**Re: INDIAN POINT ENERGY CENTER ACTIVE FAILURE ON PASSIVE
FAILURE**

John Boska on your staff e-mailed me a copy of his letter dated December 4, 2008, transmitting Amendments 257 and 238 to the operating licenses for Indian Point Units 2 and 3 respectively. Those amendments approved a change to the passive failure assumed during the first 24 hours after a postulated loss of coolant accident (LOCA).

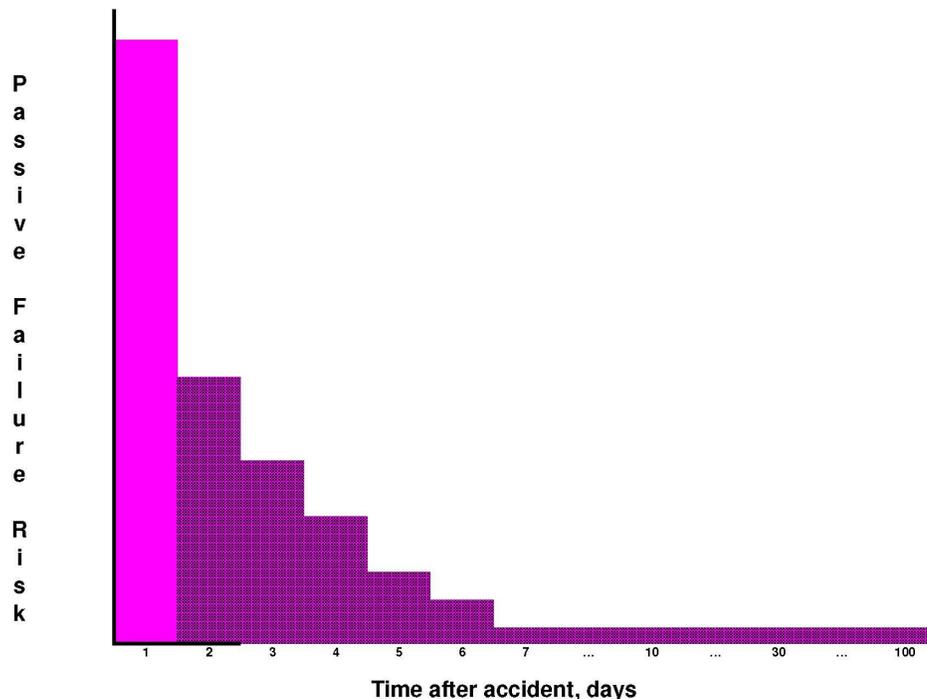
The ECCS systems in this case have a post-LOCA mission time of longer than 24 hours. It may be 30 days or it might be as long as 100 days (I could check the Indian Point design and licensing bases, but the question seems moot now that NRC has already approved the amendments). The following chart illustrates the risk of passive failure of the piping in the LOCA recirculation system as a function of time after the accident.

Curiously, although the probability of passive failure of the recirculation system piping is lowest from Day 2 through the end of the mission time, the amendments retain such failure within the Indian Point licensing and design bases. And although the piping passive failure probability is highest on Day 1, the amendments exclude it. How bizarre.

I hasten to point out that the values in the chart are for illustration only and may not accurately portray the actual (i.e., non-fiction) risk at Indian Point. But the relative portrayal is accurate in that the risk is highest on Day 1 and lower thereafter.

It very easily could be that the passive failure risk on Day 1 exceeds the cumulative passive failure risk from Day 2 through the end of the recirculation system mission time. If so, or if the Day 1 risk even approaches the cumulative risk from the remainder of the mission time, it seems absurd and improper for the NRC to dismiss the Day 1 risk on an undocumented probability basis and yet retain the Day 2-plus risk.

On technical and scientific grounds, the recirculation system piping passive failure should either be totally within or totally outside the LOCA licensing and design bases. Excluding the first 24 hours when the failure probability is highest make no technical or scientific sense.
